Sandia National Laboratories

October 2, 1989

Subject: Comments on the Draft Regulatory Guides, Task DG-7001 and Task DG-7002

- Ref. 1: Task DG-7001, "Fracture Toughness Criteria for Ferritic Steel Shipping Cask Containment Vessels with a Maximum Wall Thickness of Four Inches (0.1m)"
- Ref. 2: Task DG-7002, "Fracture Toughness Criteria for Ferritic Steel Shipping Containment Vessels with a Wall Thickness Greater Than Four Inches Thick (0.1m)"

1
 FIG. 7. Charpy data for the 8 in thick A508-4A forging.

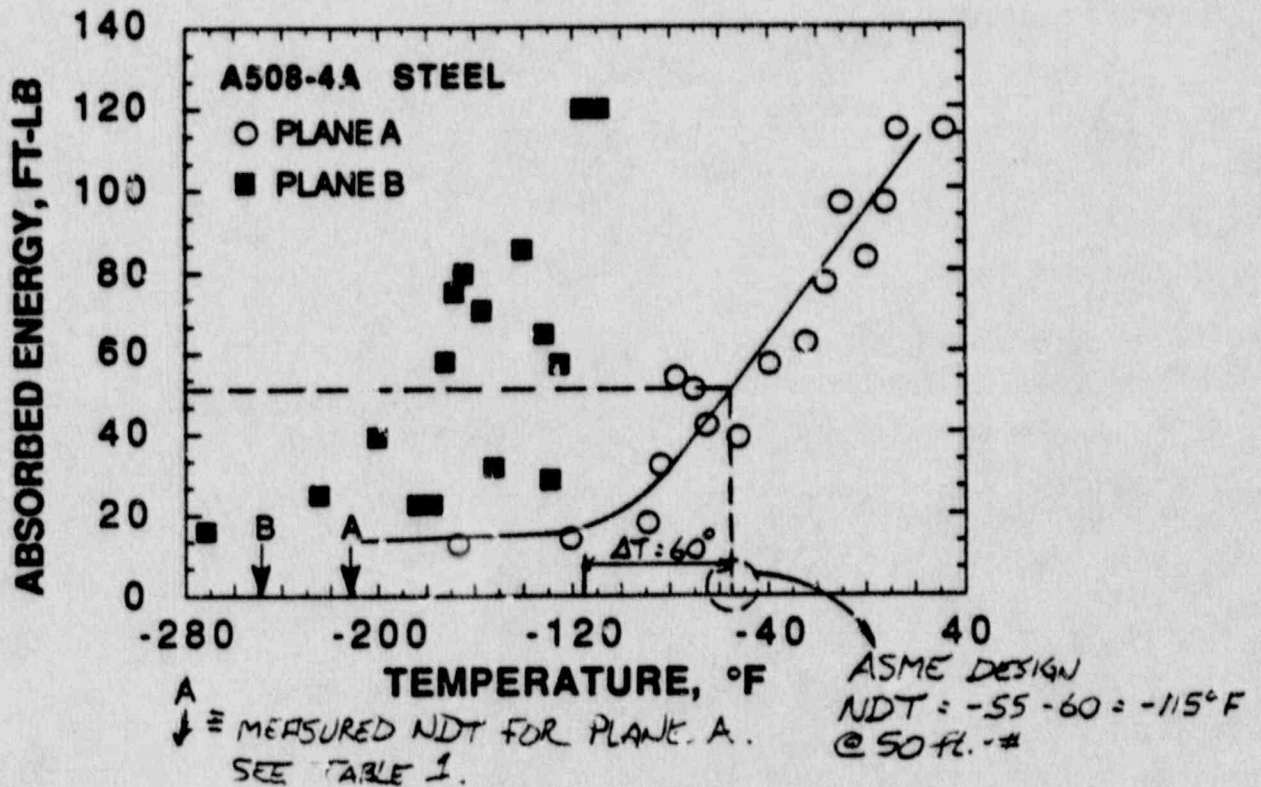
Additionally, it is helpful to evaluate the Charpy data. Figs. 1-6 show the absorbed energy vs. temperature plots for the three materials. The very low Charpy values at temperatures above the measured NDTT indicate possible brittle behavior. For example, Plane A of the SA-508-4a in Fig. 1 shows absorbed energy values of approximately 15 ft.-lbs. up to -90 C. By specifying only NDT values, other important aspects of materials behavior such as Charpy impact, are neglected.

The ASME Boiler and Pressure Vessel Code, Section III, Subsection NB-2300 imposes the Drop Weight Test to establish the NDT. However, it further requires that at temperatures at 60 F above the NDT, Charpy specimens exhibit 35 mils of lateral expansion and a minimum of 50 ft.-lbs. of absorbed energy. If these conditions cannot be met, a new NDT is established at a temperature of 60 F below the temperature at which the conditions can be met. According to the ASME criterion, it is likely that the design NDT temperature for SA-508-4a would be significantly above the measured NDT value (see Figs. 1,2). Again, using Plane A in Fig. 1 as an example, 50 ft.-lbs. occurs at -55 F. Subtracting 60 F from this value gives a design NDT of -115 F. The approved NDT temperature for this material in Ref. 2 is -150 F. Therefore, in using an ASME approach, SA-508-4a does not meet the criterion set forth in Ref. 2.
